**THE REGIONAL MUNICIPALITY OF YORK
ADDENDA # 3
T-19-16**

FOR: Construction of Paramedic Response Station No. 29 at 107 Glen Cameron Road in the City of Markham

ARCHITECTURAL ADDENDUM 01

York Region Paramedic Response Station #29

CLADDING, GLAZING, & LOUVER ELEVATIONS, I.T ROOM PLAN AND ELEVATIONS

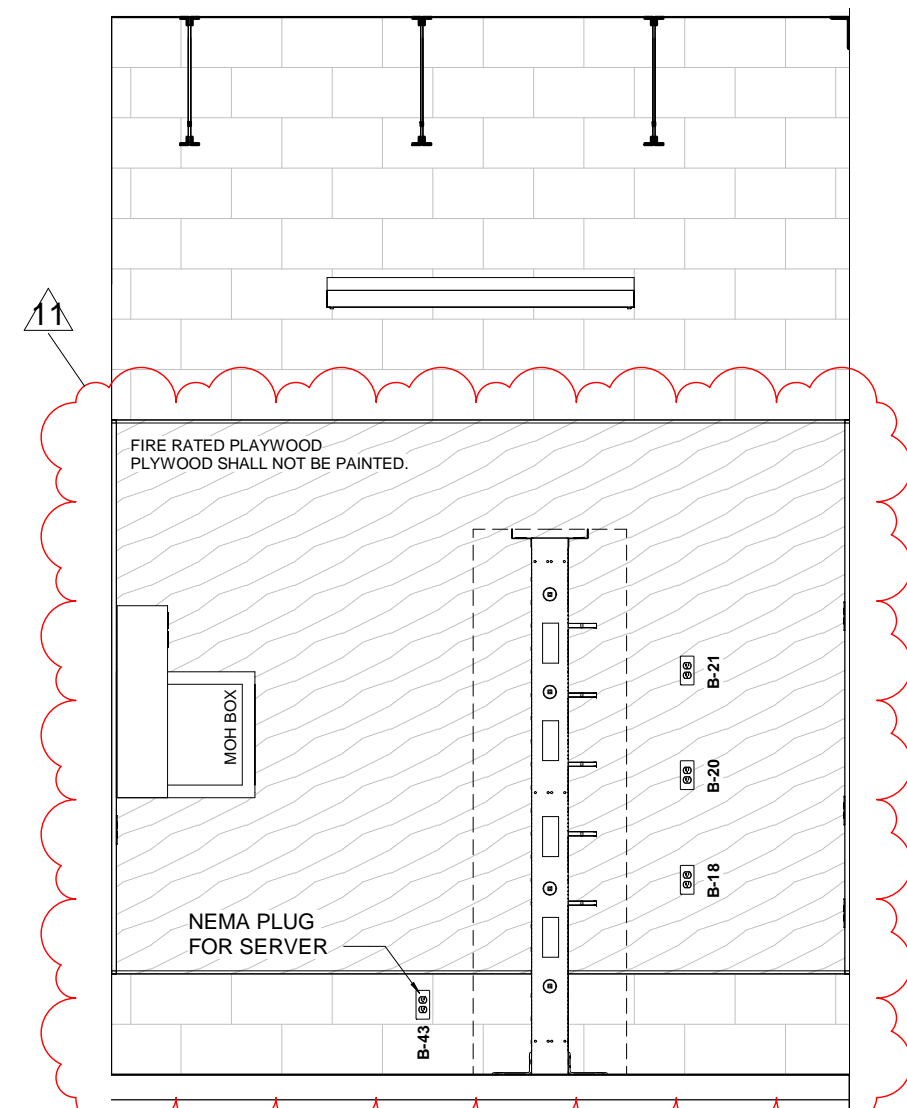
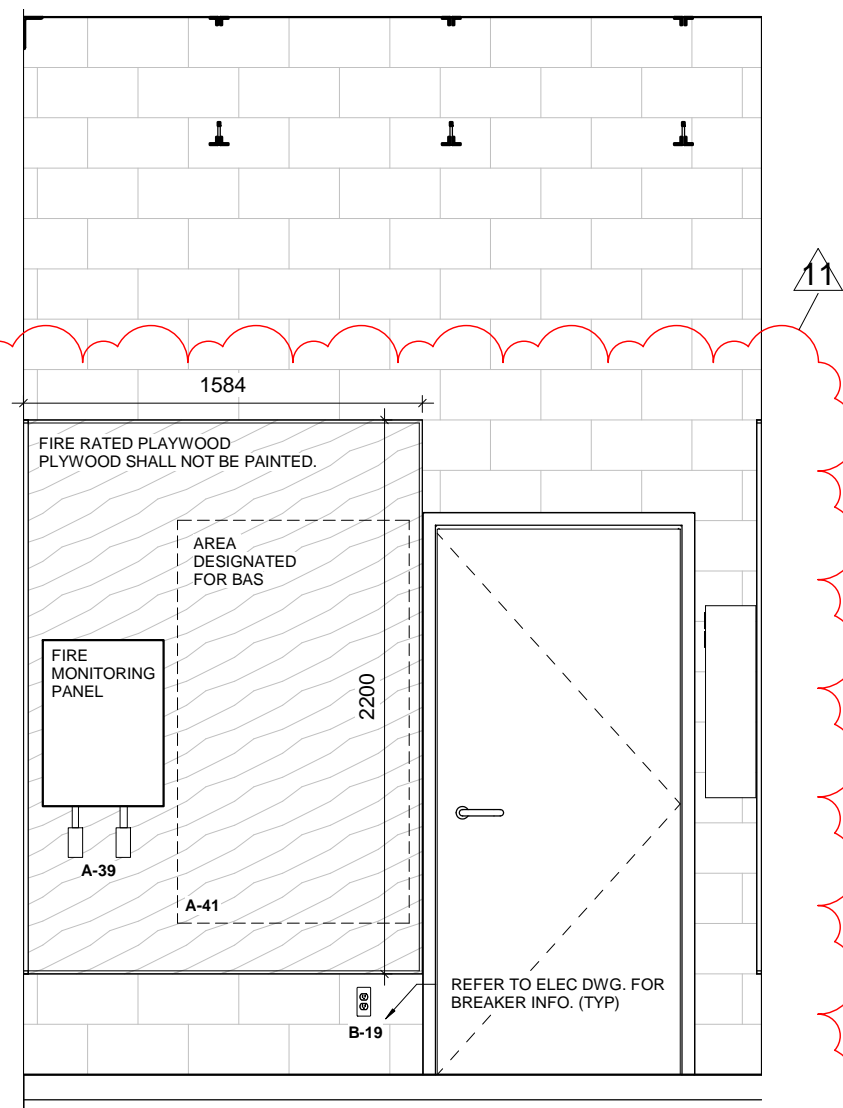
4. Refer to Drawing A4.3 Cladding, Glazing, & Louver Elevations, I.T Room Plan And Elevations

- .1 Details 17, 18, 19 and 20 have been updated to indicate electrical outlet locations for I.T room. The General Contractor shall coordinate on site with electrical Drawings and review with project team prior to rough-in. Provide fire rated plywood as indicated. Replace Details 17, 18 and 19 with the revised versions attached to this Addendum.

2 / A7.1

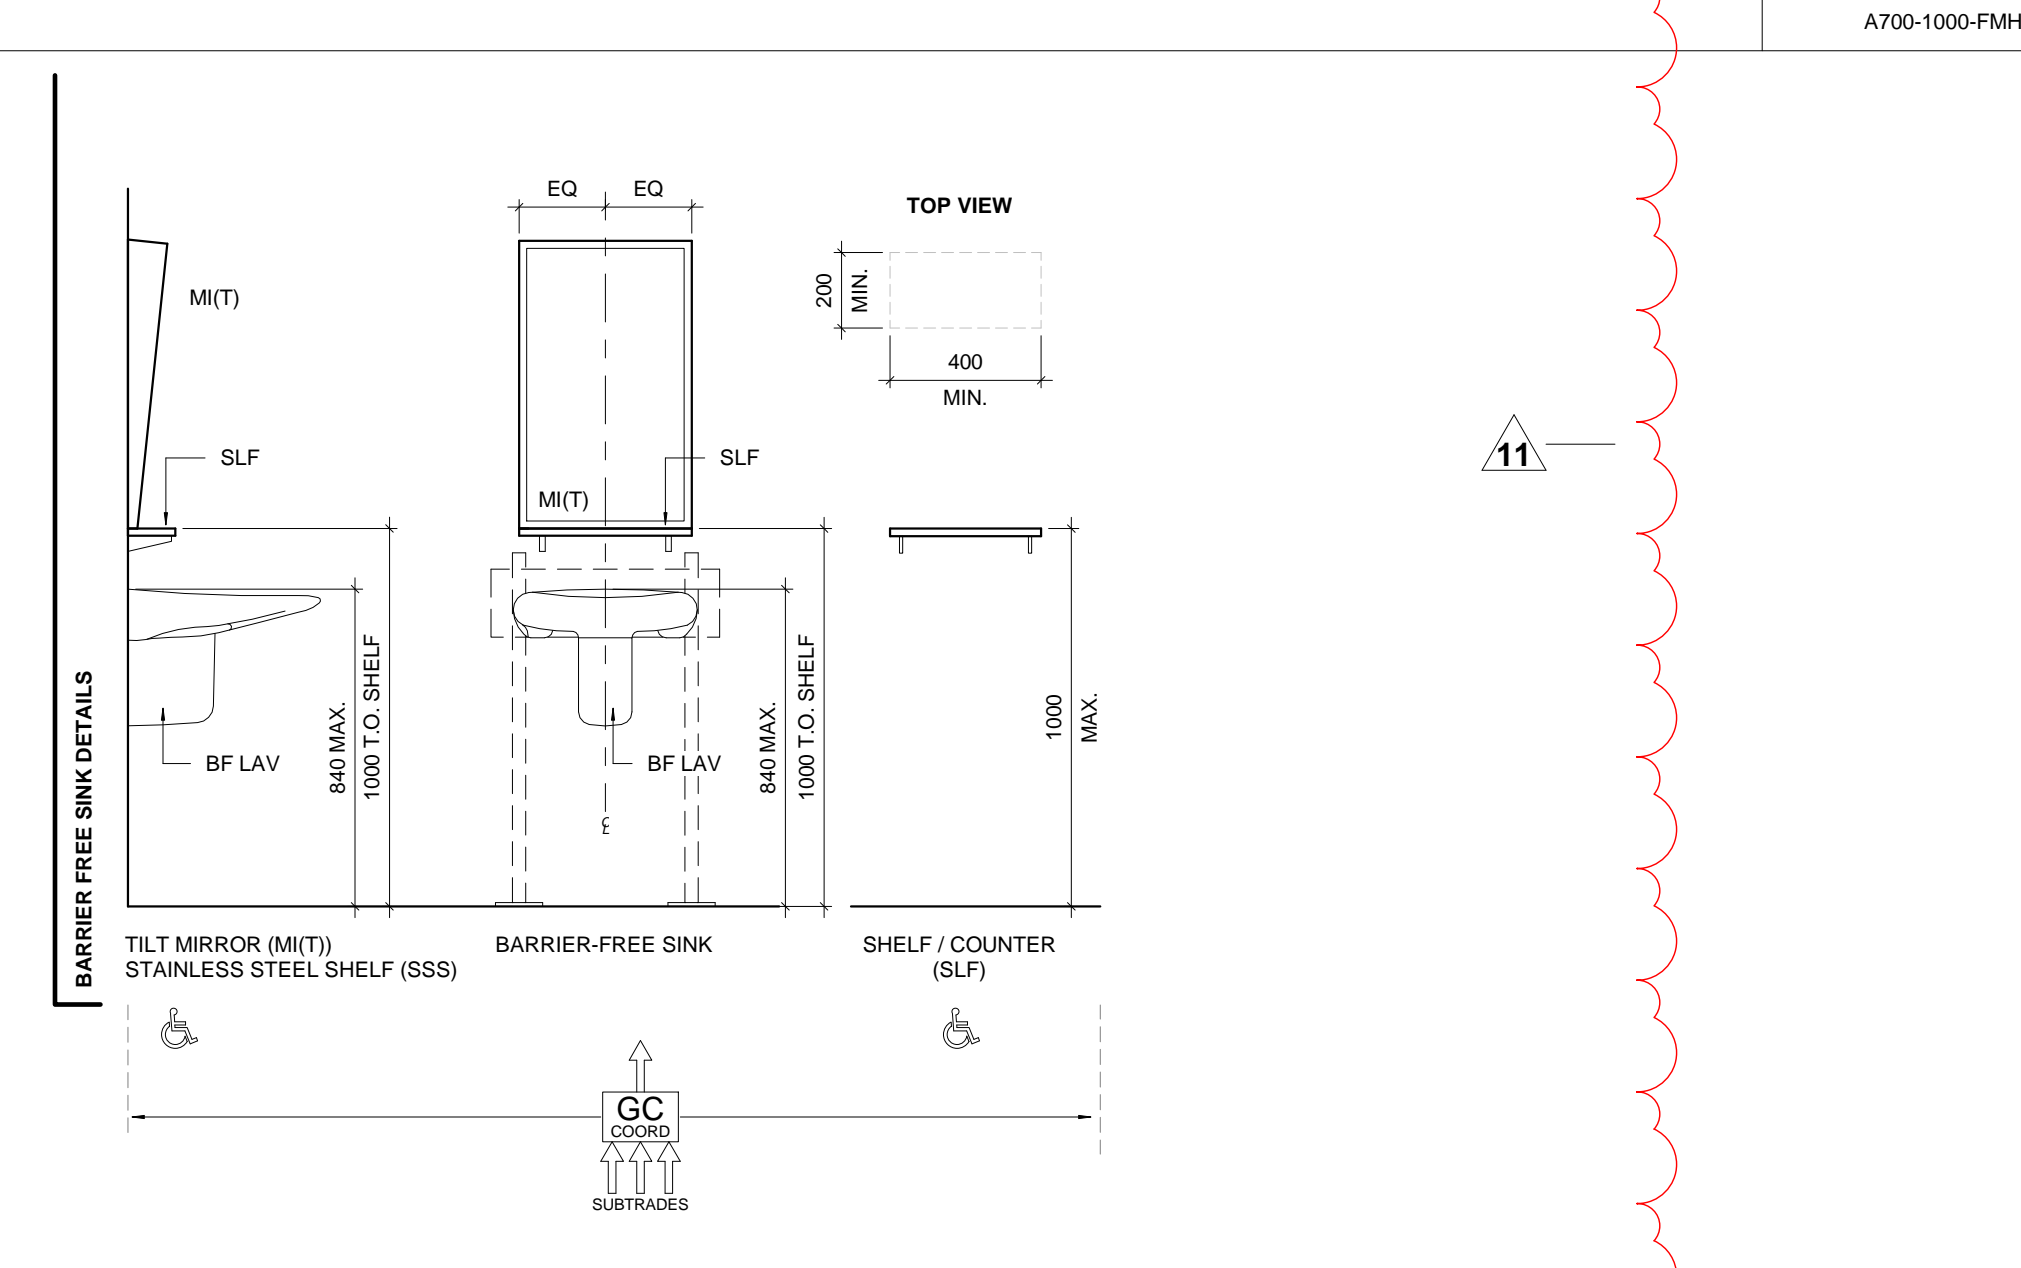
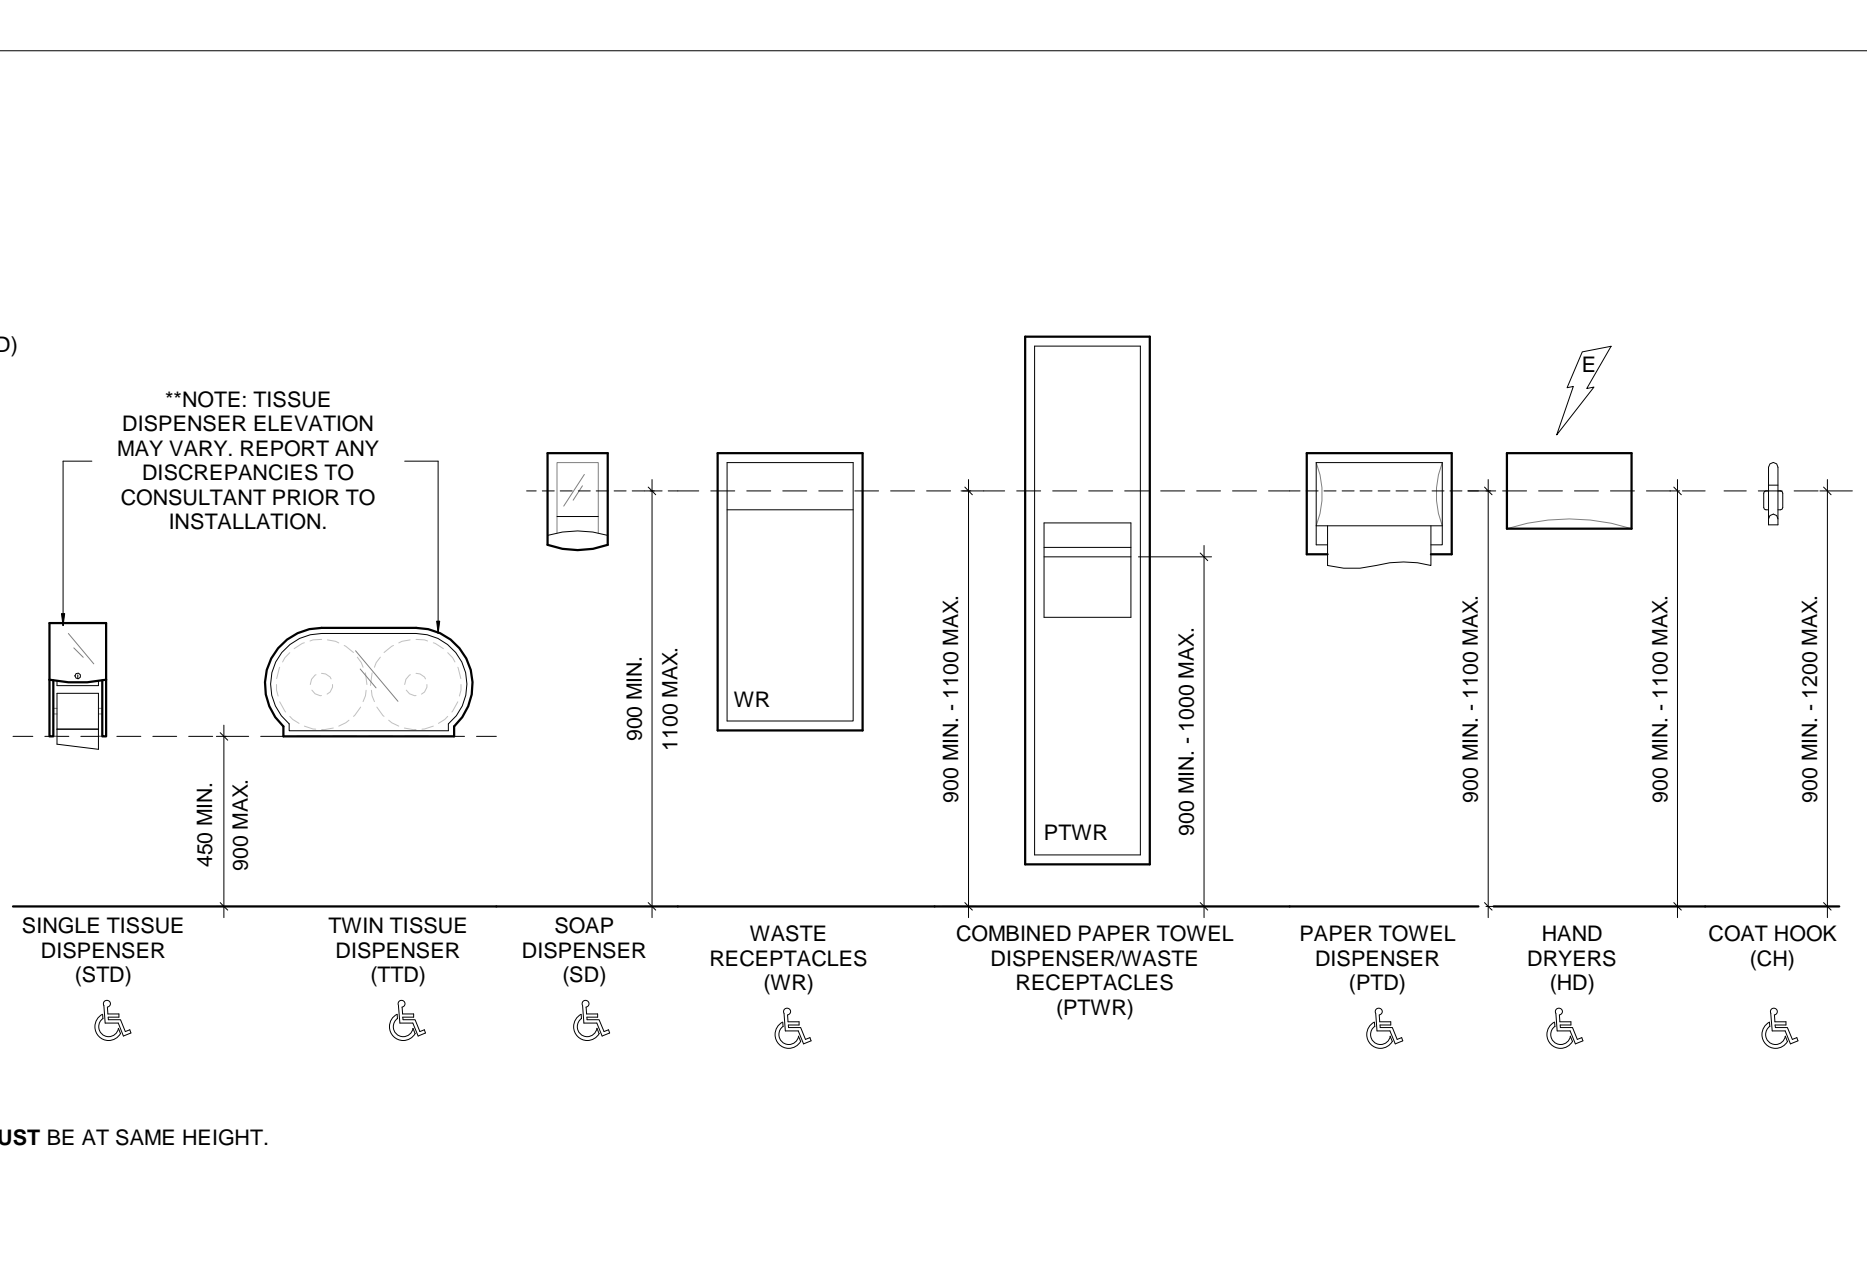
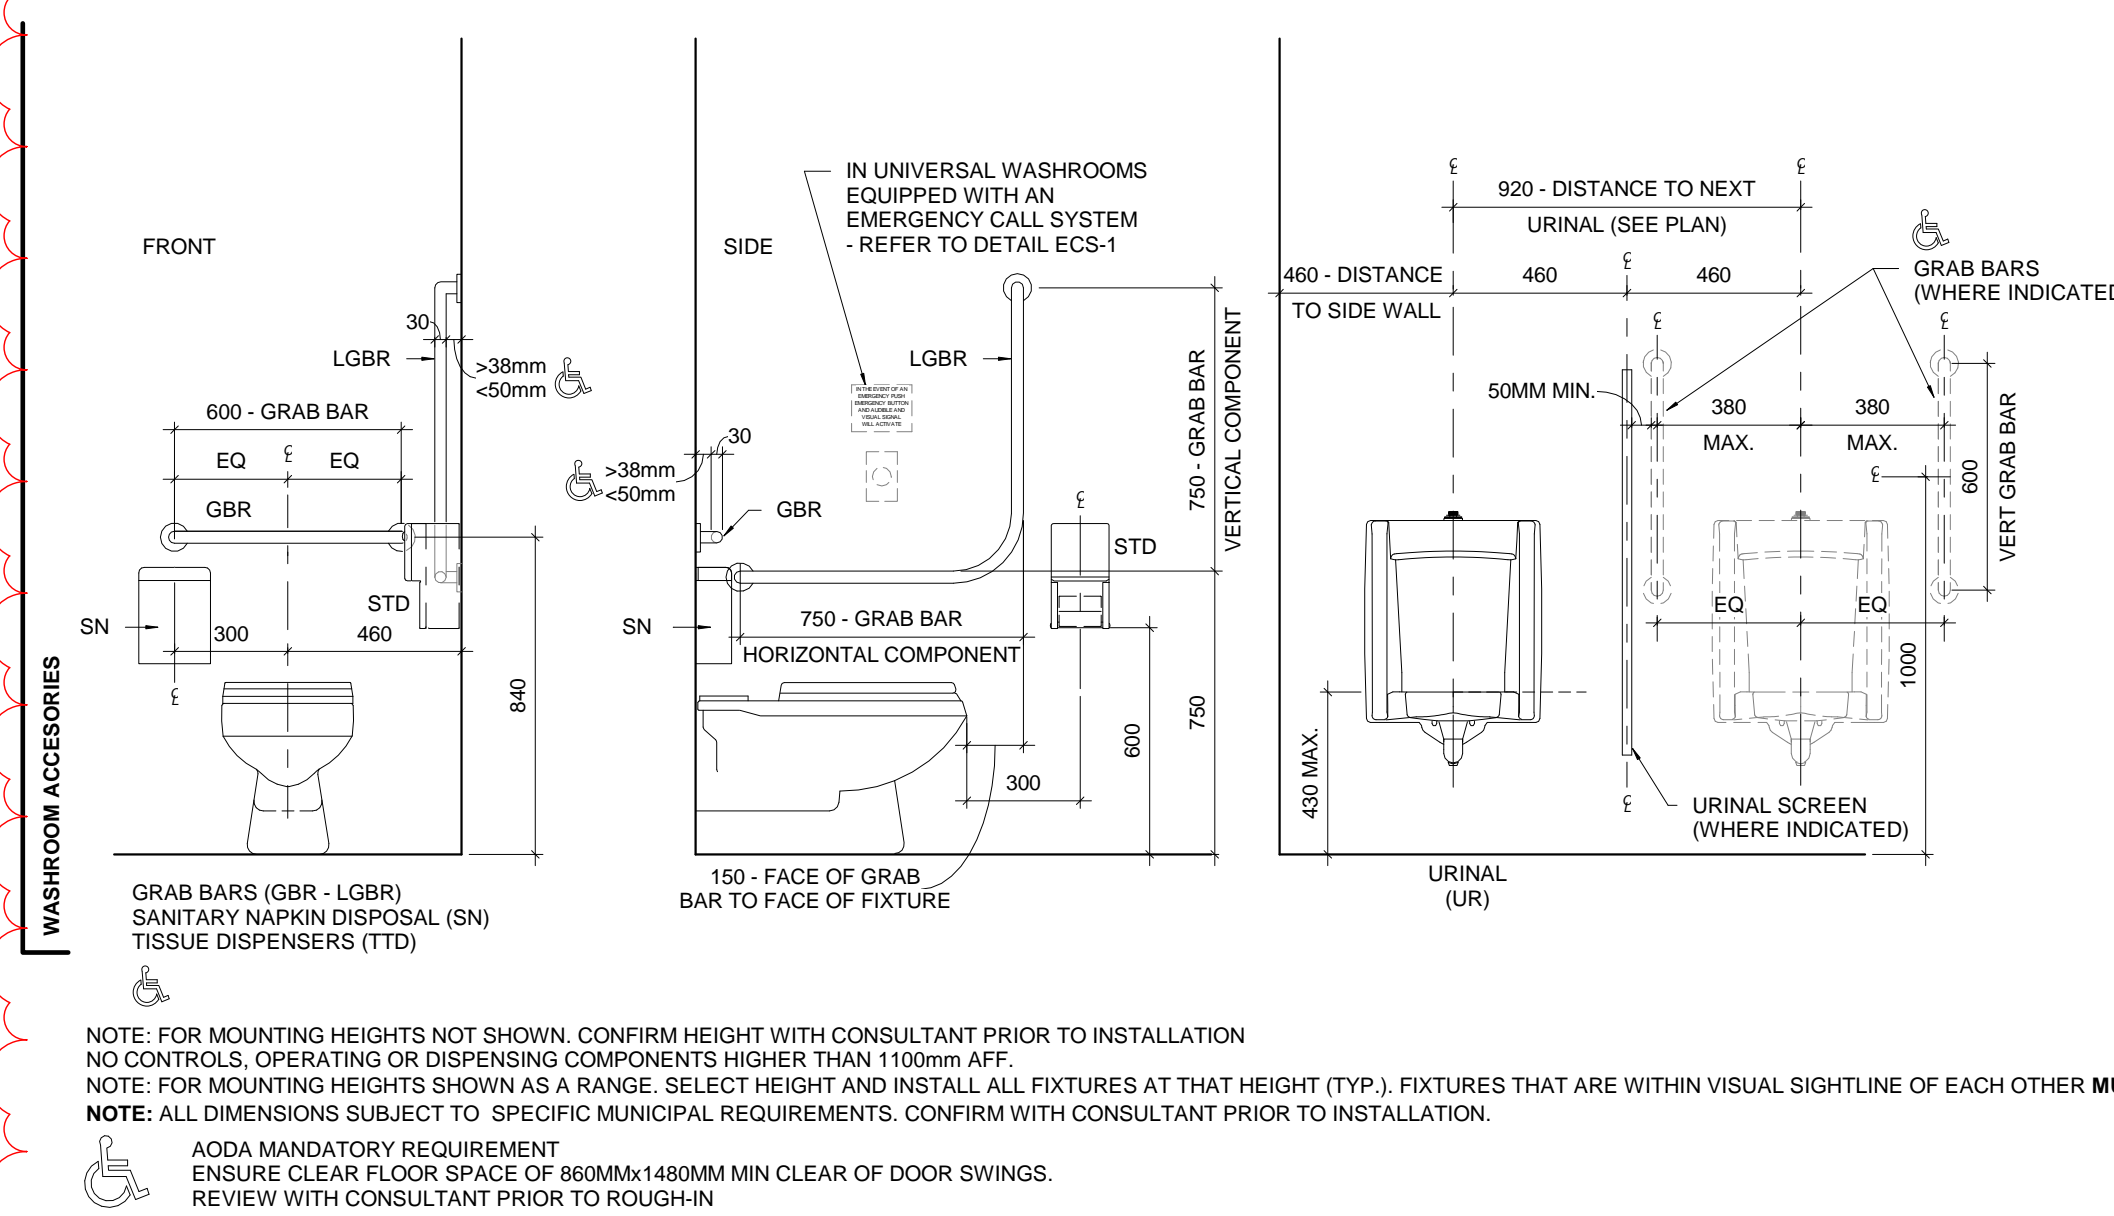
6. Refer to Drawing A7.1 – Washroom Details & Fixture Mounting Heights

- .1 Replace detail 2 and 3 with the revised versions, which are attached to this Addendum.
